Re: Site-Specific Risk-Based Cleanup Level Calculations, Draft Annotated Outline for Risk-Based PCB Cleanup Plan, and Responses to Comments, Former Westinghouse Apparatus Repair Plant, Rancho Dominguez, California

Enclosure C - Response to EPA's Comments from May 18, 2016

CBS Post Cleaning Sampling – Former Westinghouse Facility, Rancho Dominguez, CA

EPA R9 Comments – May 18, 2016

FIGURE 3

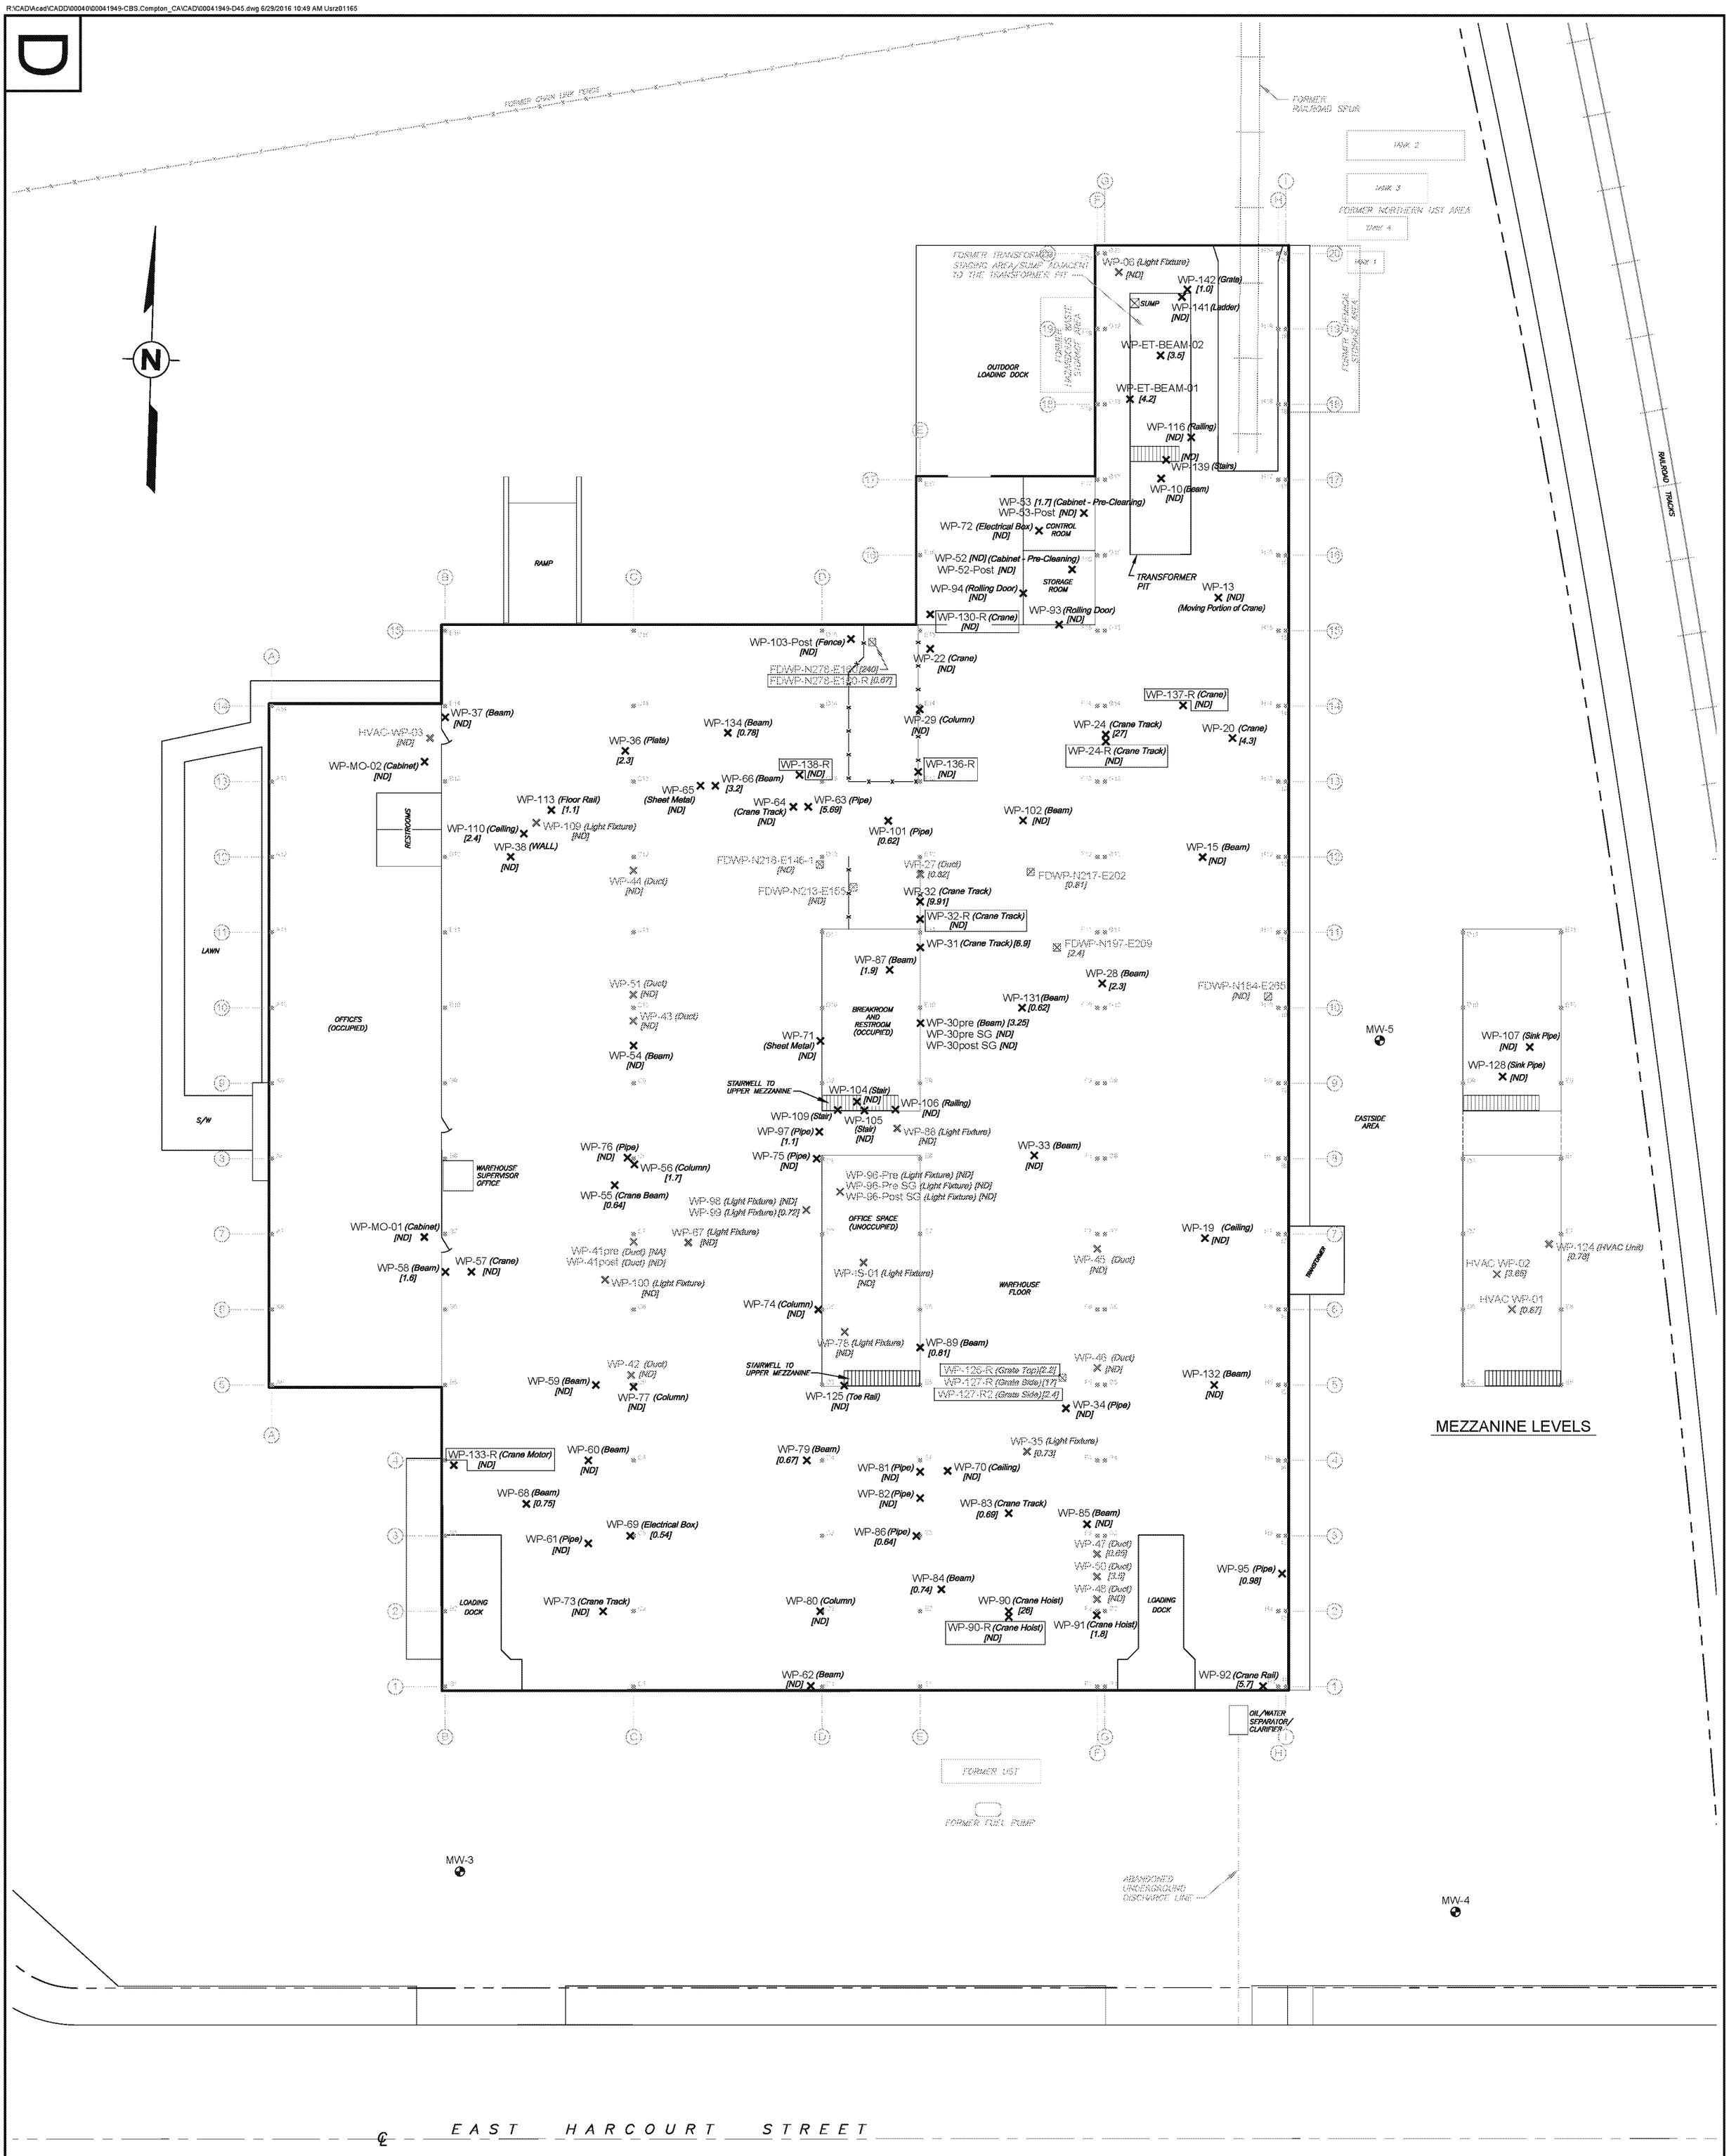
a. We would like to further evaluate this data and need additional figures. Please provide a figure that properly identifies each of the wipe samples collected (1) after cleaning and (2) after re-cleaning.

The samples of the re-cleaned surfaces are identified by the letter "R" at the end of the sample identification shown on both the figures and tables. On the revised wipe sample figure (enclosed), sampled identifications are boxed to denote a "re-cleaned" sample.

Notably, most of the surfaces that were re-cleaned are associated with the crane and crane rails that were found to contain oil and grease that were not easily removed using the Simple Green™ solution. The greasy equipment was re-cleaned using undiluted solution and more aggressive scrubbing techniques.
